# STAFF RECOMMENDATION

NCPC File No. 6402

**DEPARTMENT OF JUSTICE HEADQUARTERS BUILDING  
PERIMETER SECURITY UPGRADES  
PRELIMINARY SITE AND BUILDING PLANS  
950 Pennsylvania Avenue, NW  
Washington, DC**

Submission by the General Services Administration

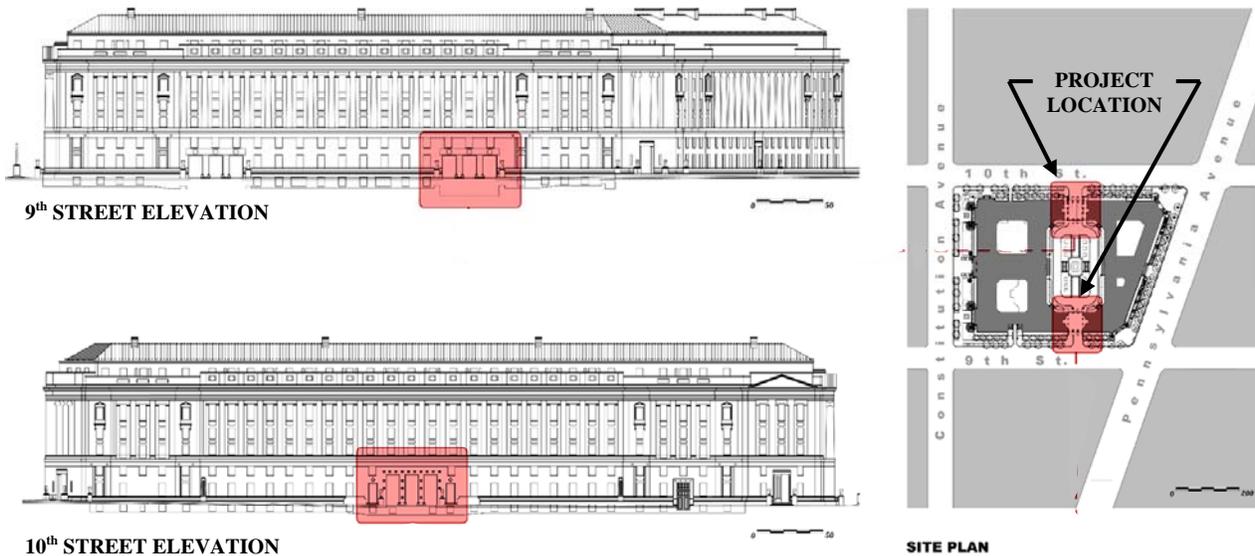
- **Approves** the preliminary site and building plans for perimeter security upgrades at the 9<sup>th</sup> and 10<sup>th</sup> Street entrances of the Department of Justice Headquarters building at 950 Pennsylvania Avenue, as shown on NCPC Map File No. 1.23(38.00)-41253.
- **Requires in the submission of final site and building plans:**
  - Modify of the vehicle gate top enclosure to be more compatible with the historic architectural style of the building, and to provide a smooth design transition where the top of the gate meets the historic, interior roof portal detailing.

**STREET-SIDE PERSPECTIVE SIMULATION OF VEHICLE GATES and BOLLARDS with RAILINGS SEEN AT RIGHT and LEFT OF PORTAL ENTRY**

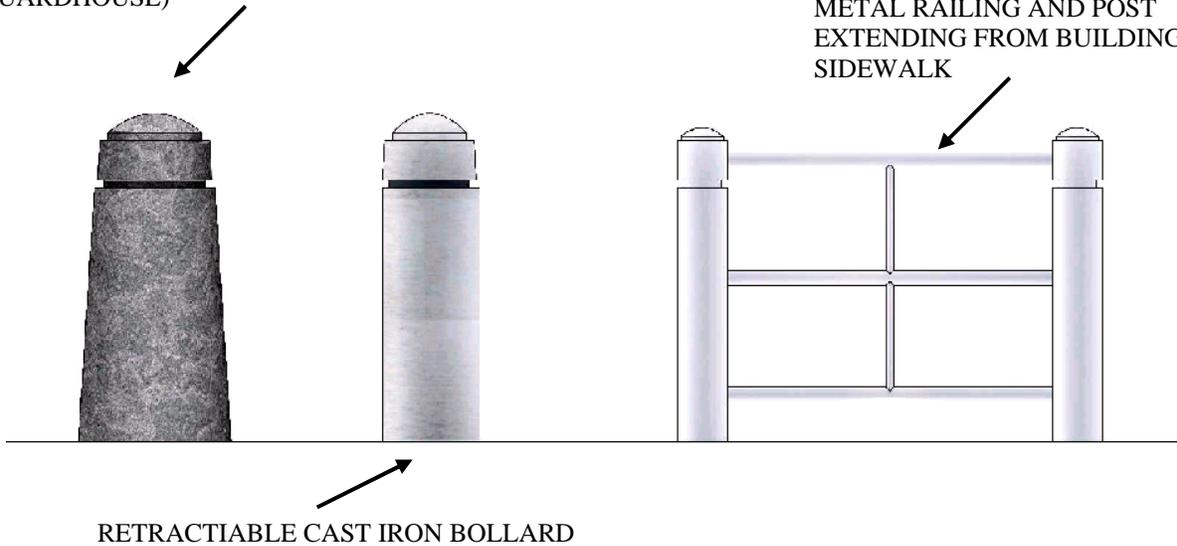
DOJ representatives and their design team met with Commission staff in the winter of 2002 and the late spring of 2003, and staff made recommendations based on the UDSP that were offered to guide the design proposal. While staff recognizes that significant design effort and conformance to architectural principles have crafted the design's commendable appearance, there are aspects to the submittal that have not demonstrated recognition of the goals of the UDSP. Perhaps most

significantly is that the proposal, in the context of the streetscape enhancement and public realm beautification, does not demonstrate the high level of unification sought by the UDSP. The streetscape portions of the project (bollards, railings, and their relationship) still overstate their separate appearance as a system of components whose only purpose is security. Additionally, staff review has found the top enclosure area of vehicle gates, even though recessed, is too intrusive to the building portal and extends high above the gate doors, which adversely impacts the visual and spatial characteristics of the exterior and interior portal space. Although DOJ representatives had offered to review this aspect in early consultation meetings, no redefinition of this element has occurred. Staff believes a reduction in the top enclosure height and removal of the seal emblem is appropriate to achieve a more balanced context to the vehicle gate appearance and its relationship to the important entry (See page 10).

Staff recommends approval of the preliminary site and building plans but requires modification of the vehicle gate top enclosure and the exterior metal railing design illustrated in the plan. Staff believes a refinement in the railing elements can be gracefully established utilizing the portions of the currently selected features, and perhaps others as identified in the UDSP, to provide perimeter security in a manner that does not clutter the public realm, while avoiding the monotony of bollards or the incompatible assemblage of several different elements – which appears to be the potential direction of the submitted design (See site plan at page 11). Staff recommends the Commission require GSA to assist DOJ in re-evaluating railings used in the

current design, along with their location, and provide a final project site and building plan that more closely reflects the design elements and the hierarchy of streetscape design framework on the north-south streets of the Federal Triangle highlighted in the UDSP. Moreover the effort should incorporate a fence and bollard wall, if at all possible, on the curbside of the streets in the future comprehensive perimeter design at DOJ that should also feature tree planting beds.
